**BECKER, LLC**  
**Wawa Convenience Store and Fueling Station**  
**Special Exception Use Application**  
**P22-006**

Planning and Zoning Board Meeting

February 7, 2023

# Concept Plan

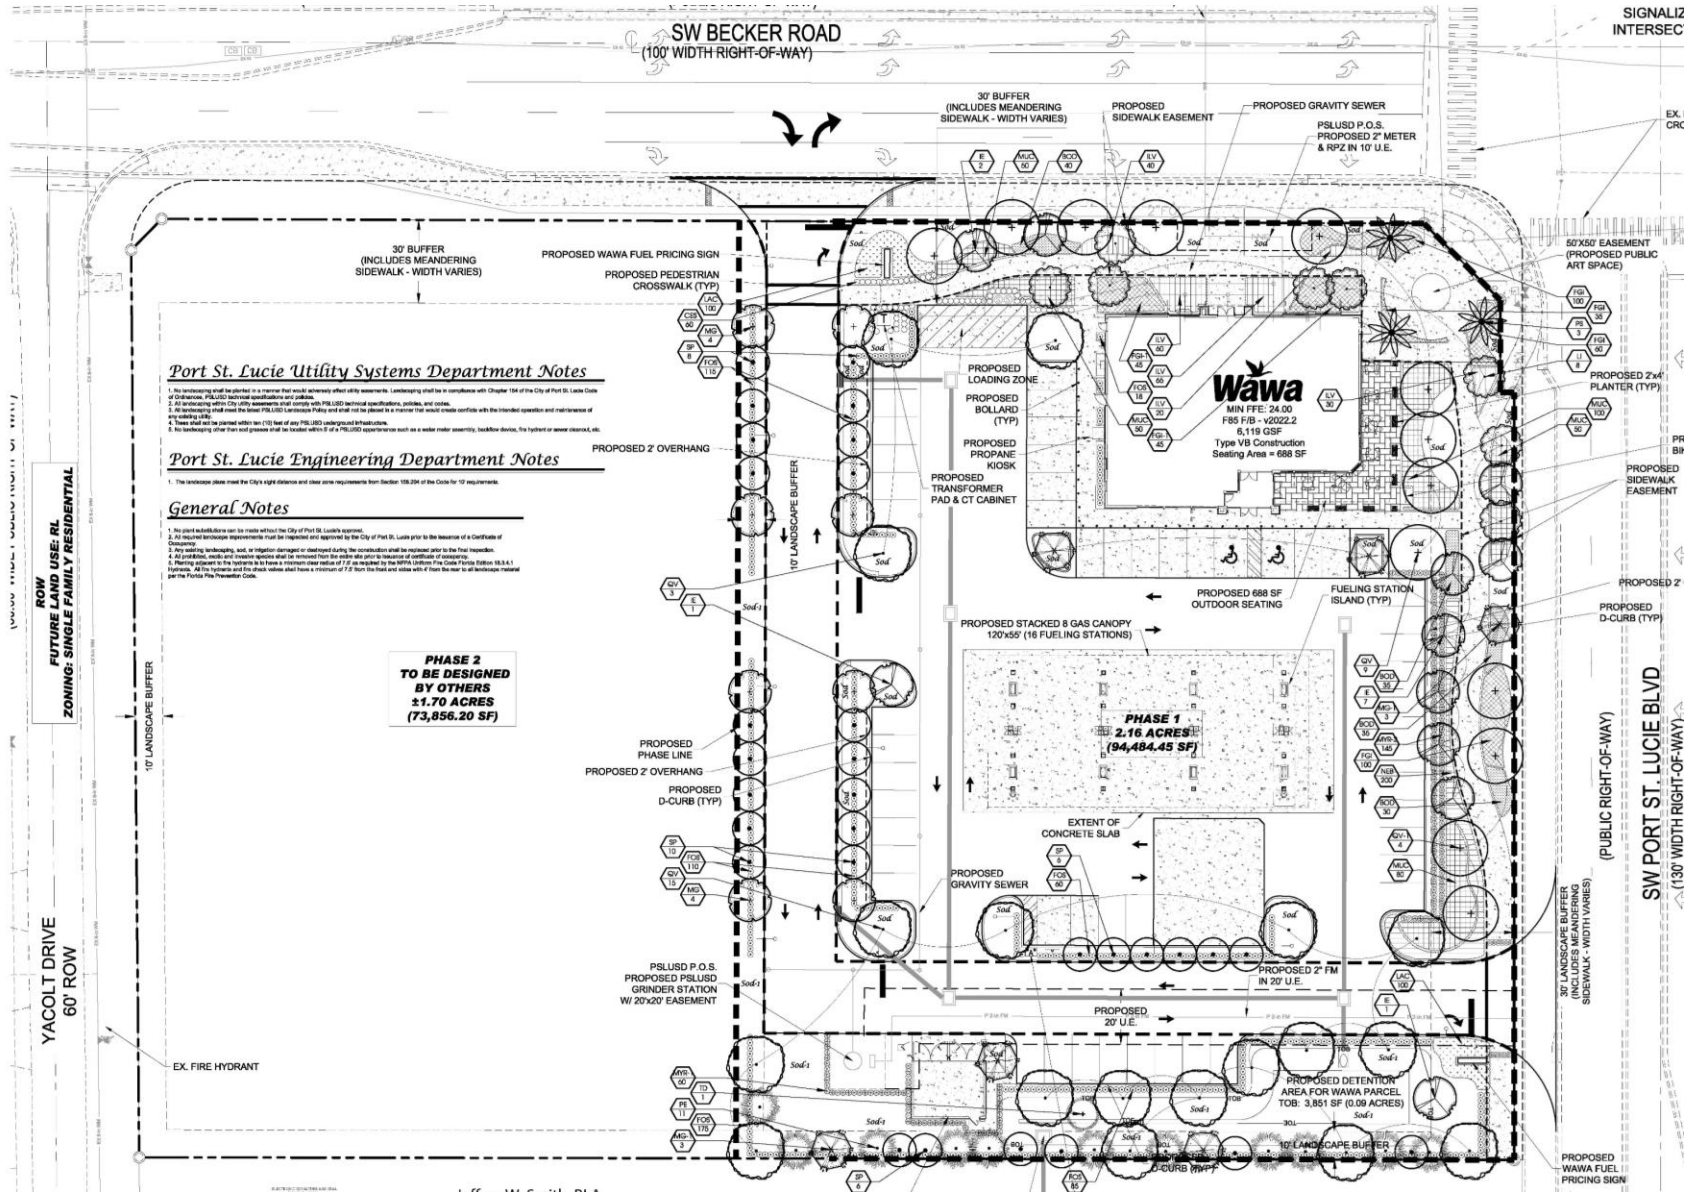
- **1. Public Works does not support the placement of the mid-block driveway located in the Becker Road right-turn lane. [Remove or relocate the mid-block driveway so that it is not in the functional area of the Port St. Lucie Blvd. & Becker Rd. intersection.]**

- **2. Public Works does not support the spacing distance of the mid-block driveway from Yacolt Drive. [The spacing does not meet the minimum 250-foot distance. The proposed spacing is 243.27 feet.]**

Shows mid-block driveway extending from right-turn lane. Public Works does not support.

- 1) Becker Road Mid-block Driveway Access: Staff finds the requirements of Zoning Code Section 158.224, Driveway Spacing from Intersections, to ensure public safety and high-quality public infrastructure have not been met and staff finds that there are viable alternatives that would not create a potentially hazardous driveway configuration at this location. The proposed mid-block access driveway located on Becker Road shall be eliminated. The Conceptual Site Plan shall be updated prior to SEU approval by the City Council.

## City Code Non-Compliance

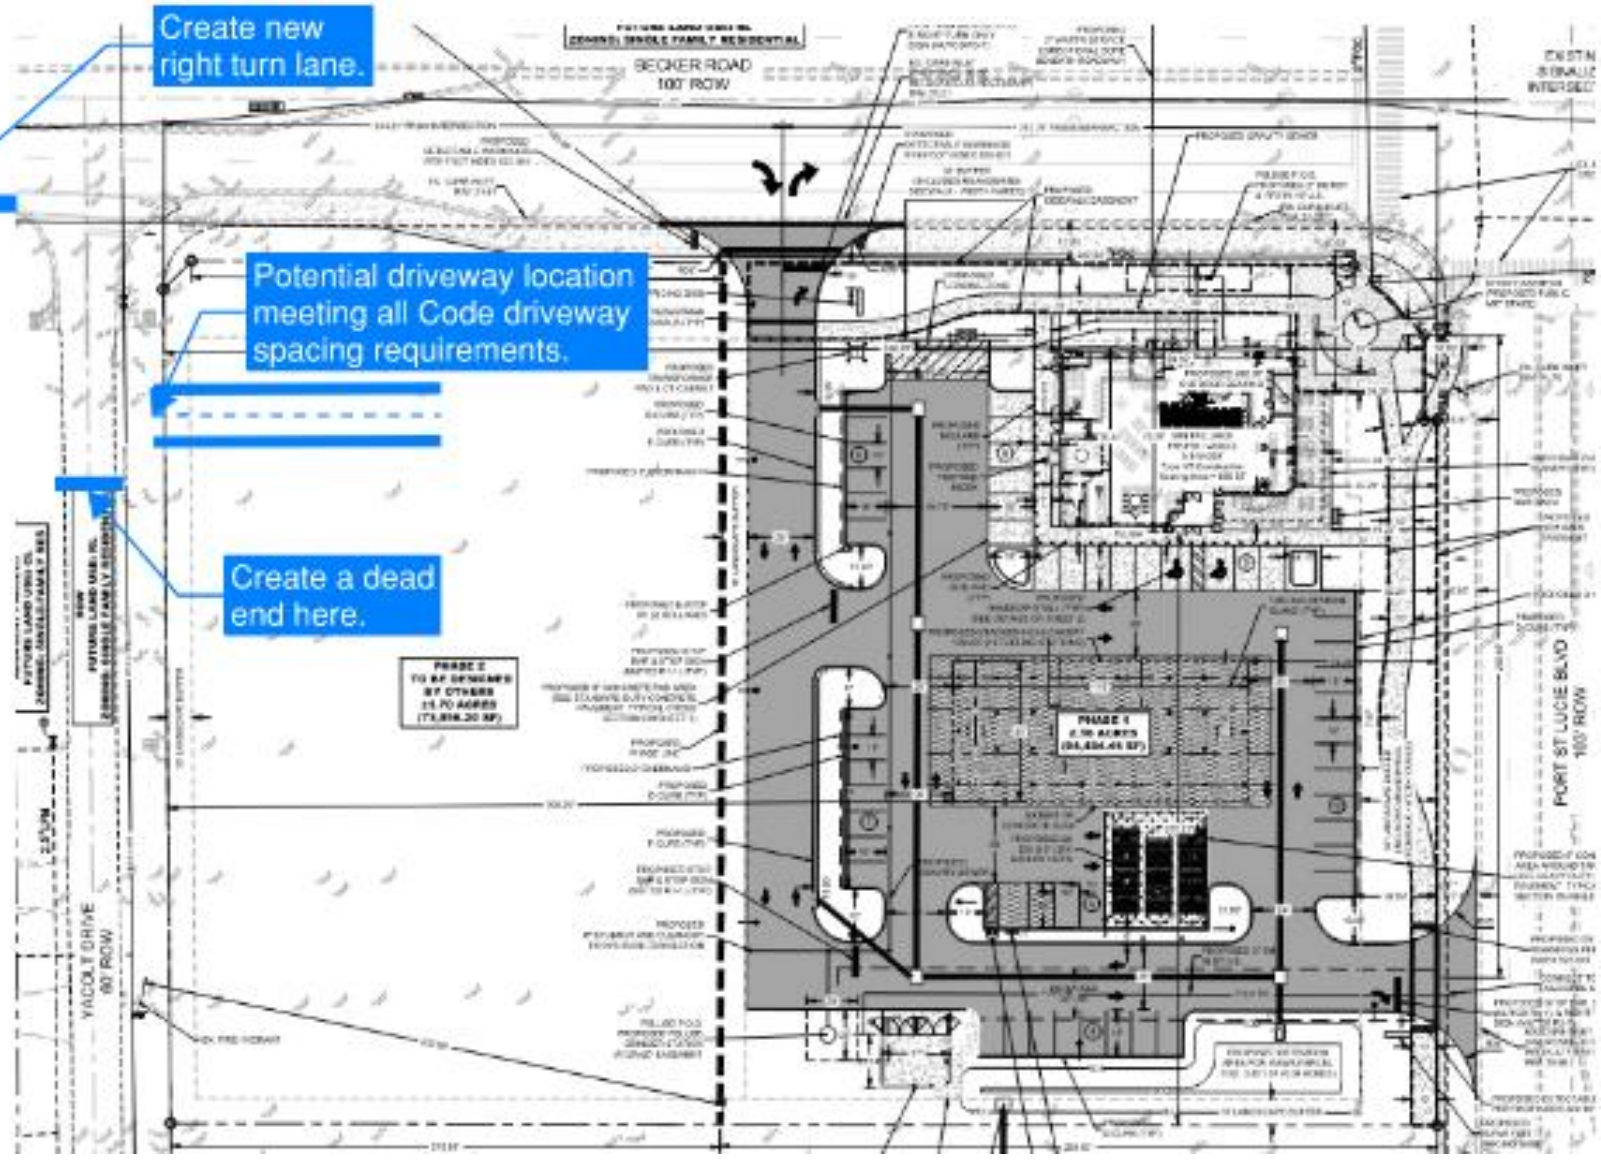
Zoning Code Section 158.222(B)(4), driveway spacing from intersections shall be measured at minimum of 250' from middle of driveway to the right-of-way line of the intersecting street. Applicant is proposing driveway at 243' from Yacolt Drive.

Of more concern to the Public Works Dept is the location of the driveway being within the existing right turn lane of the Becker and Port St. Lucie Blvd intersection. City Code states, “standards in excess of these spacing requirements are preferable and may be required for driveways located within the functional area of an intersection or areas where access restrictions are necessary to reduce conflicts, preserve the safety of the traveling public, or to preserve the function of the adjacent roadway.”

The proposed driveway location within the functional area of the intersection will create additional conflict points and therefore creating a safety concern.
